ANSWERS TO THE FIRST ROUND OF QUESTIONS

On the International Architectural Competition for the Reconstruction and Rehabilitation of the Al Nouri Complex in Mosul

Deadline to submit questions: 7 December 2020
Date of publication of the answers: 14 December 2020

Al-Nouri Complex layout plan

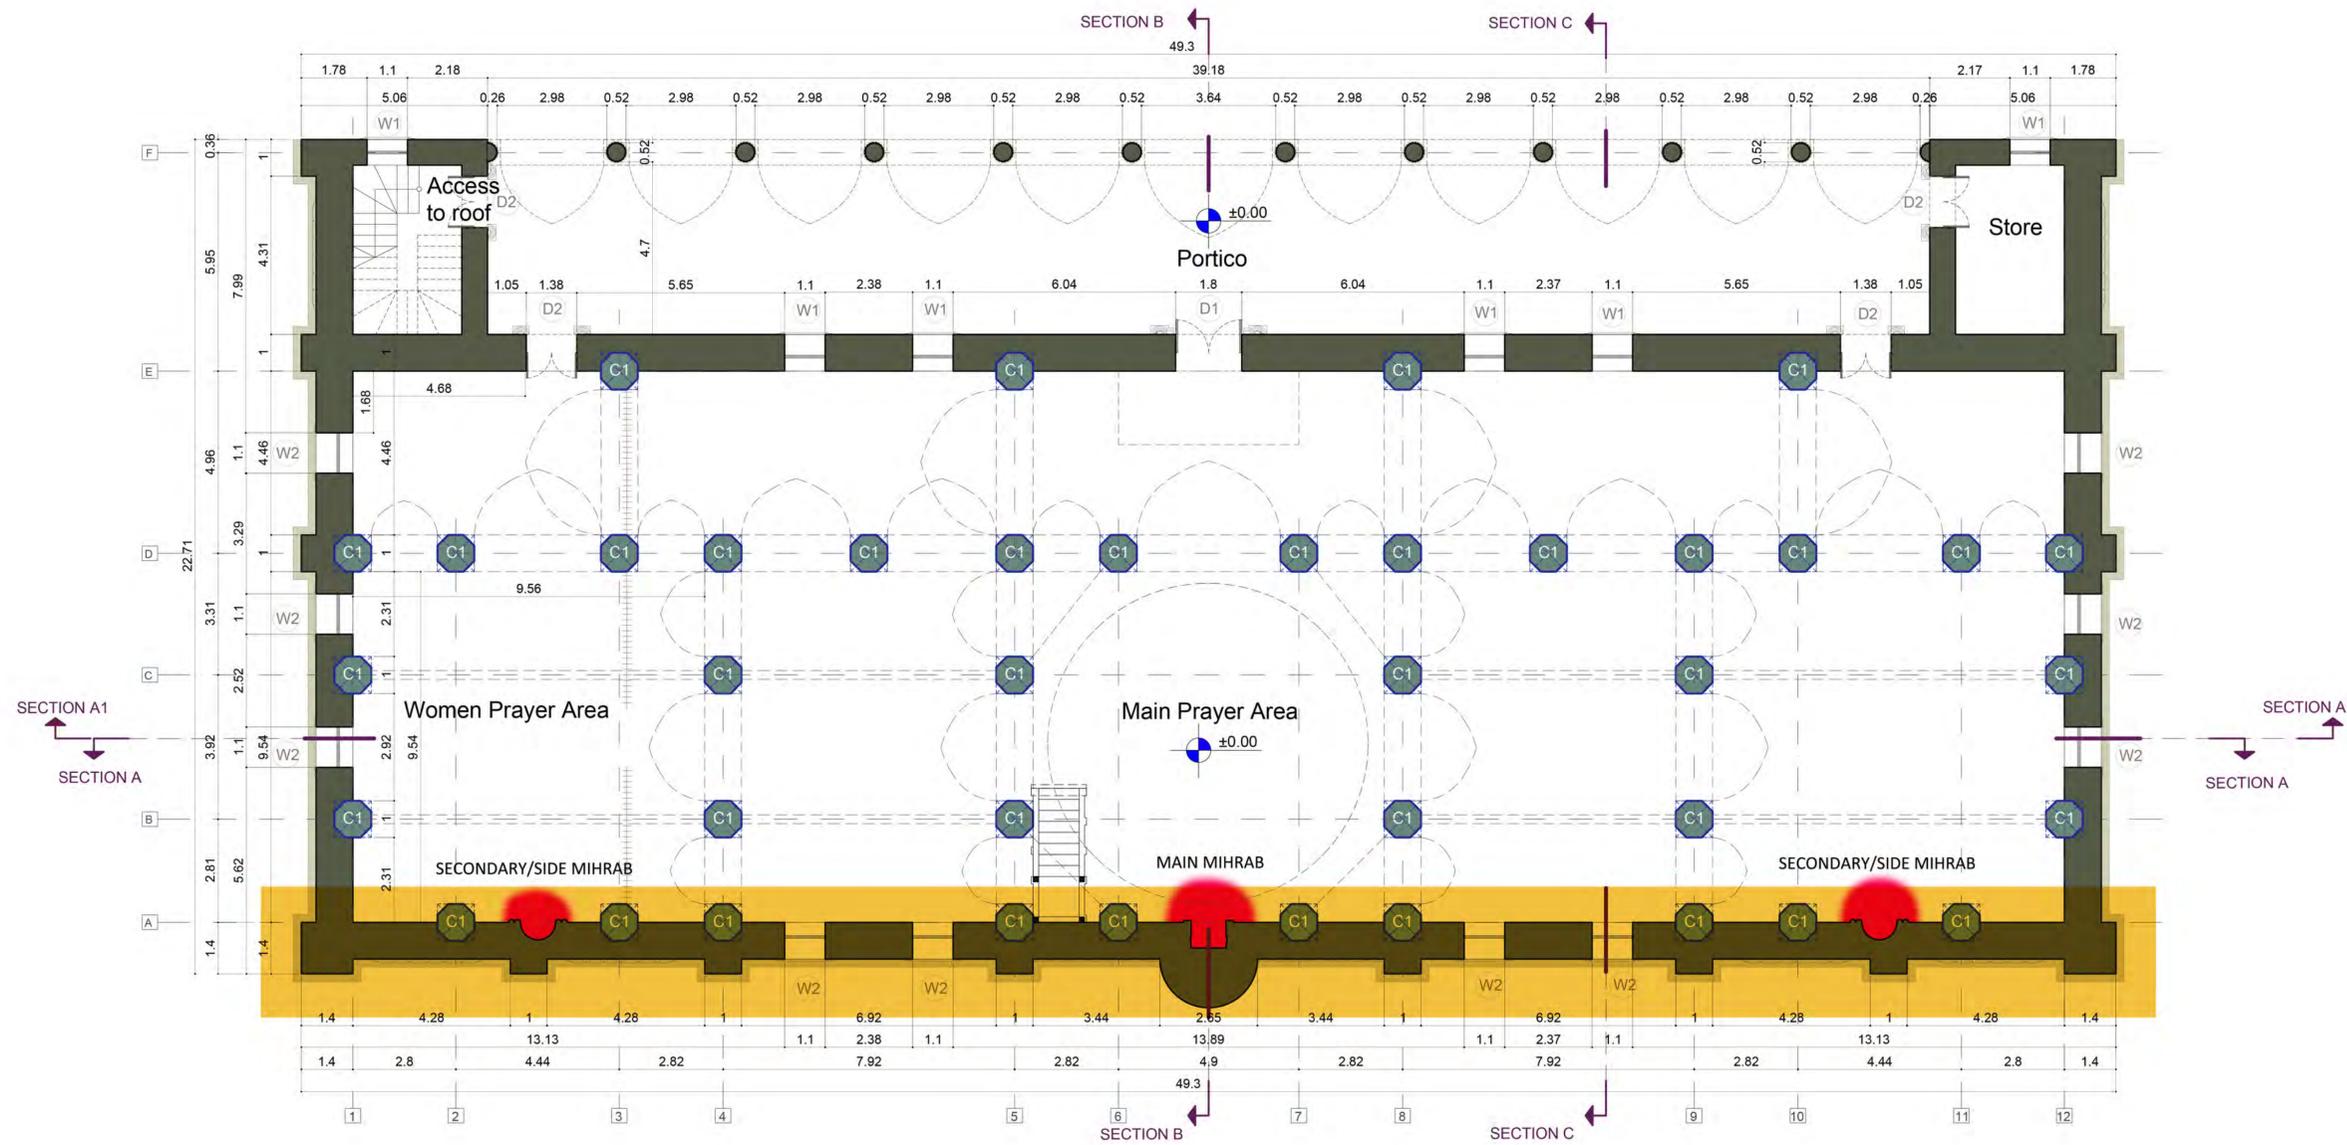
- ①②③④⑤⑥⑦ houses 1,2,3,4,5,6,7 are all out of our design scope, correct?
- ⑧⑨⑩ houses 8,9,10 are to be redesigned (should be redesigned to be identical to the previous design (in material, elevation and exterior design) or can we proposed a design that can speak to the remaining standing structure?

- ⑪ are all the area indicated in (note 11) suggested for the new functions? Can we suggest new areas for the function to be compatible with the urban design?

- ⑫ Is the rehabilitation of prayer hall (note 12) should be identical to the previous design (in material, elevation and exterior design) while preserving the remaining standing structure? Or can we do a new design for the destroyed prayer hall. A design that can speak to the remaining standing structure?

- ⑬ Is the rehabilitation of structure 13 should be identical to the previous design (in material, elevation and exterior design)
- ⑭ should we design the new building on the North street with 5 meter setback?

- ⑮ should we design the new building on the Farouq street with No setback?
- ⑯ should we design the new building on the Great Mosque street with No setback?

- ⑰ Our design will consider that the temporary structures shall eventually be removed from the site, correct?
- ⑱ To be sure. Hadbaa minaret is out of our design scope, correct?

- ⑲ Can we suggest new landscape/connectivity to the out of scope area (meaning the Hadbaa minaret and the historical dwellings (1-7)?

- 1,2,3,4,5,6 and 7 - Do not make part of the present architectural design competition.
- 8, 9, 10 - Please see the answers to the other participants questions.

- 11 - NO. Some of the areas marked by you on the plan with no.11, are proposed for demolition, while some are proposed for new functions. Please refer to Appendix B: BR.A-100 Demolitions Plan and BR.A-101 - Building Regulations plan, sections and elevations.

- 12 - Please see the answers to the other participants questions.
- 13 - Represents the Hexagonal Ablutions pavilion which dates from the beginning of the 20th century (around 1925). The structure of this pavilion was reinforced probably in the 1950s, when a concrete supporting structure was added around it. This later intervention will be removed and the Ablutions pavilion will be consolidated and rehabilitated.

- 14 - The building(s) on the North street may be designed with no setback from the street. However, we recommend the portion of the building facing the street not to be higher than 6 meters.

- 15 - The building(s) on Farouq street may be designed with no setback from the street.
- 16 - The building(s) on the Great Mosque street may be designed with no setback from the street.

- 17 - Temporary structures will be removed from the site.
- 18 - Al Hadba minaret is not part of the present architectural design competition.
- 19 - Yes, you can propose connections with the Al Hadba minaret and the northeast dwellings.
